Requests for information – Minor Applications

1.1. Stewartville CP17-008

ATTACHMENT 1.1 A

BSR-CS5-UW-002 (Rev a)

1999 Design Drawing - signed

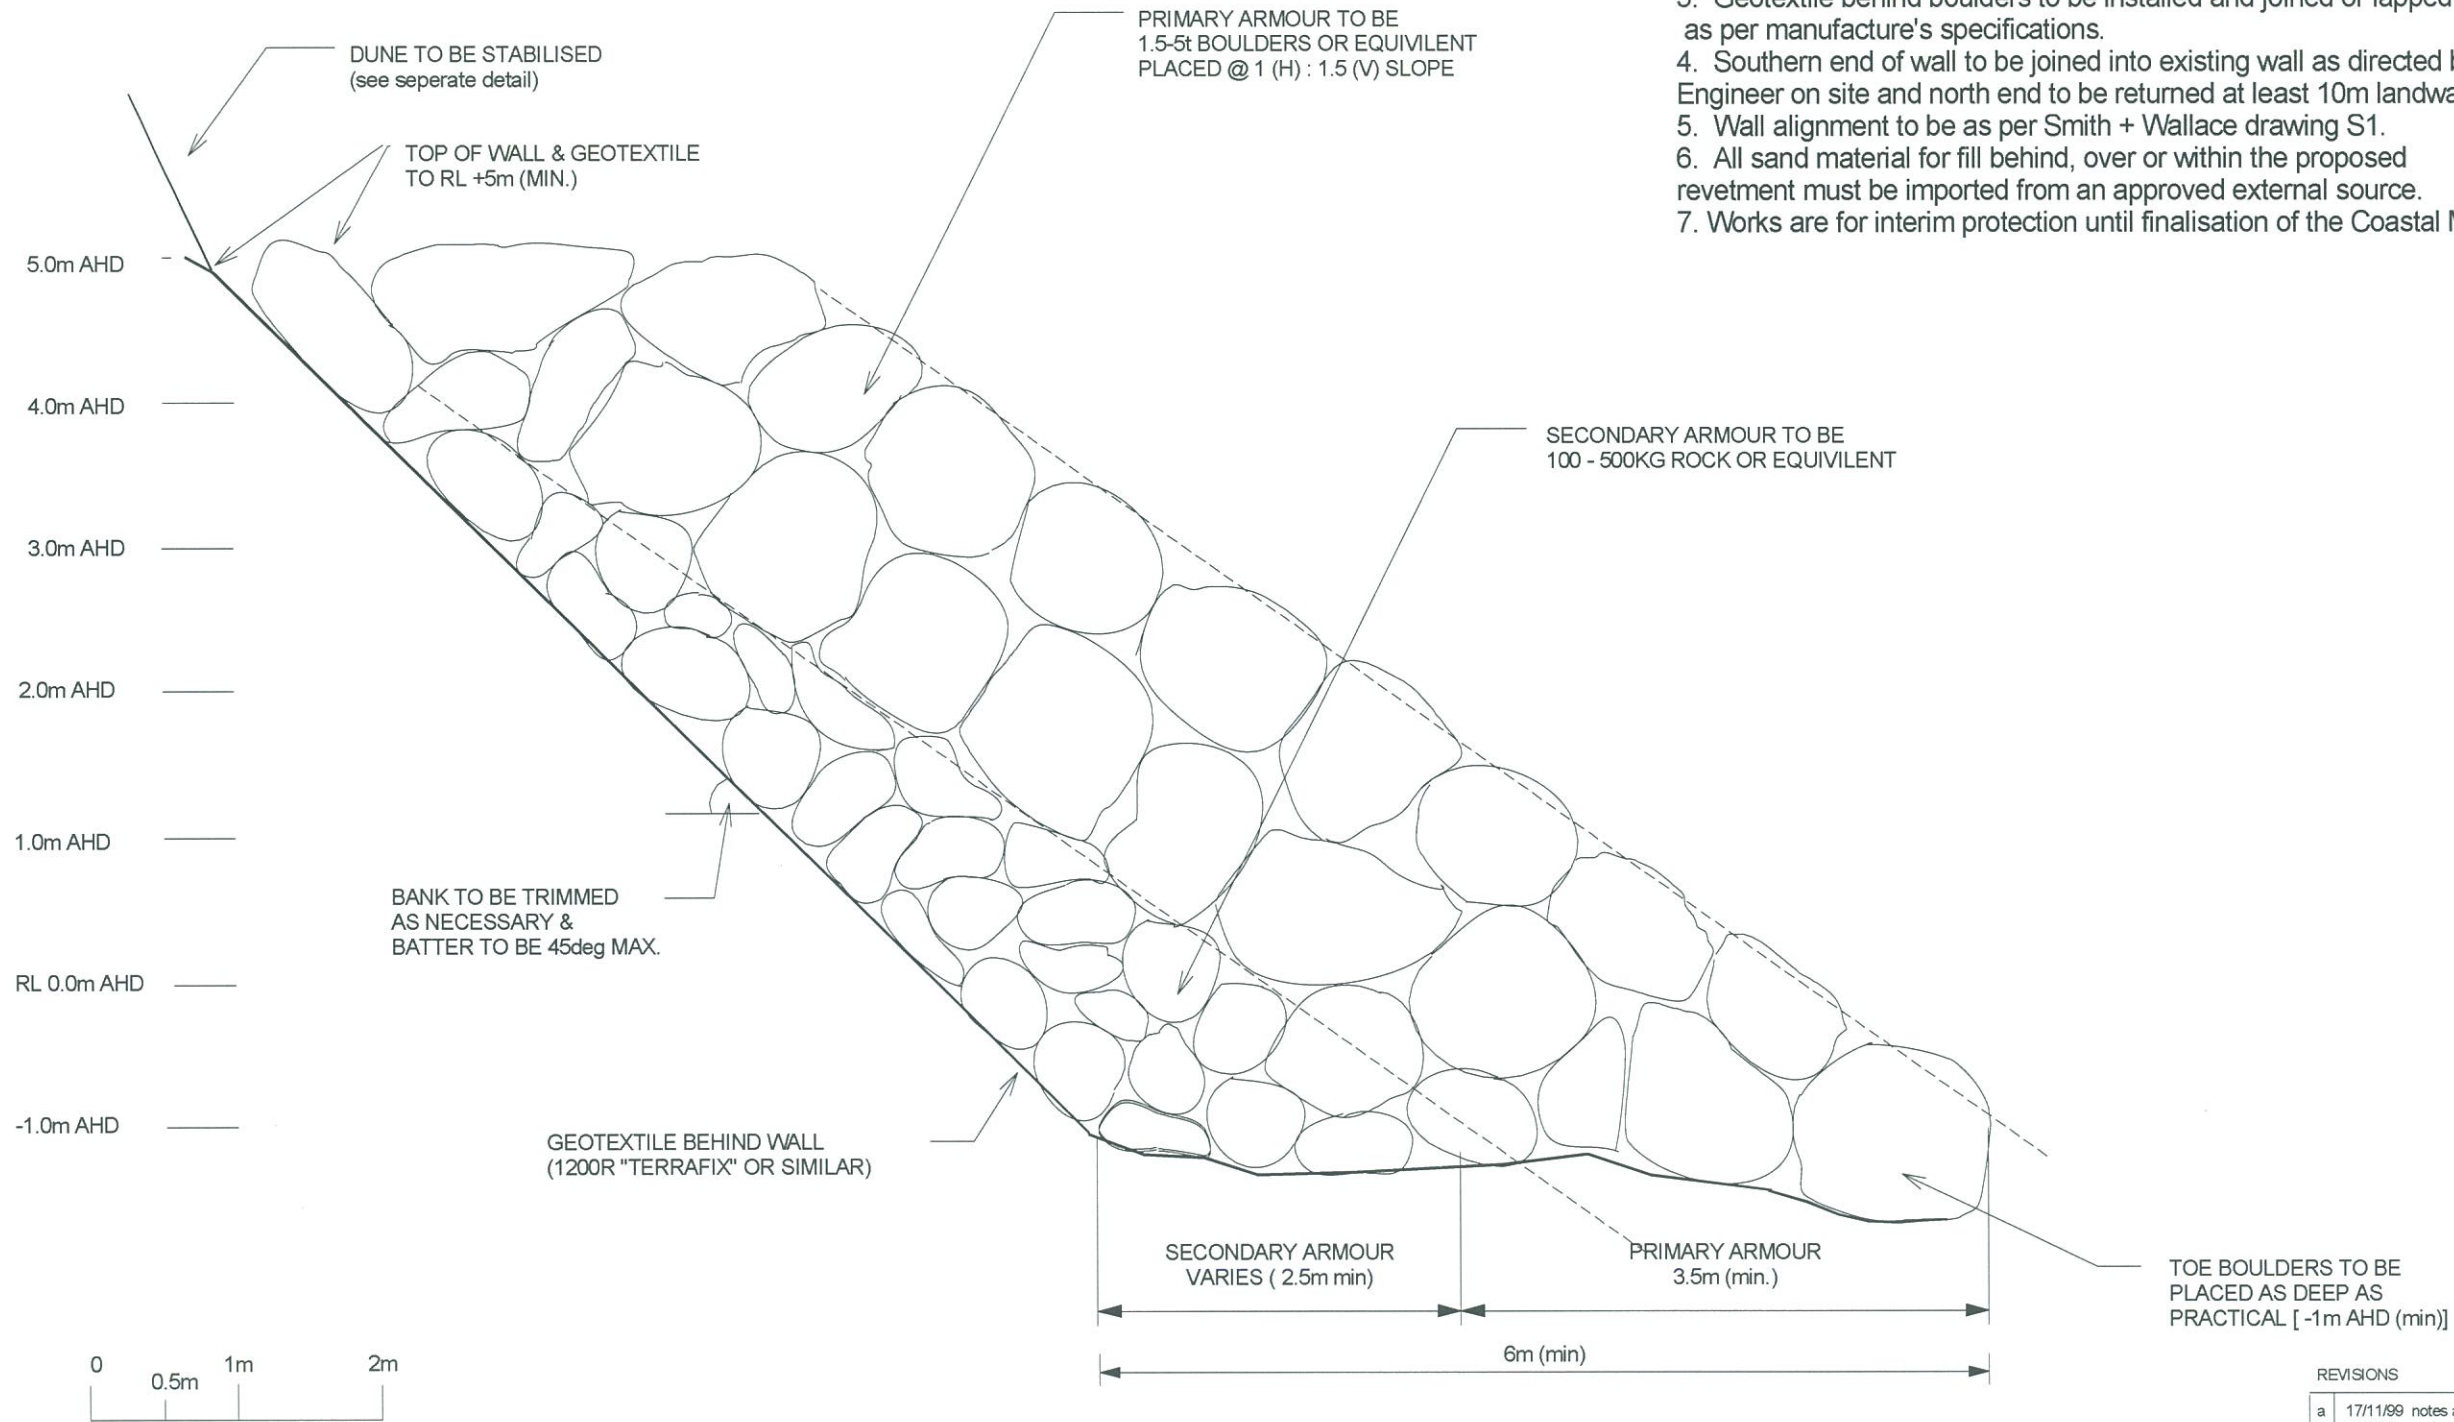
8.	<p>Please provide:</p> <p>a. a full (signed and dated) copy of the design and "as constructed" drawings for the 1999 works; and</p> <p>b. a legible and dated A3 copy of the "Canty survey" provided in the DA materials.</p>	<p>a. We have already provided you with a copy of the design.</p> <p>A signed copy of this design is attached as Attachment 1.1 B</p> <p>No "as constructed" drawings have been located in our records, but ICM confirm that the as constructed profiles were in accordance with the design profiles.</p> <p>b. Please identify the copy to which you are referring.</p>

4.	Grading and specifications of the existing layer of primary armour stone	<p>We have already provided this information. As per previous advice (ICM Report August 2017 Section 3), the wall was constructed with sound (unfractured) primary armour with 50% of the rocks in the primary layer to be greater than the average of the weight range specified (1.5-5t). As per previous advice (ICM Report August 2017 Section 3), the wall is substantially</p>

unchanged except for about 1m of slump and that "some of the rocks now exposed on the seaward face are smaller than 1.5t."
5.	Details as to whether any rocks or other materials forming part of the existing structure are to be removed from the site.	No rocks or other materials are to be removed from site.
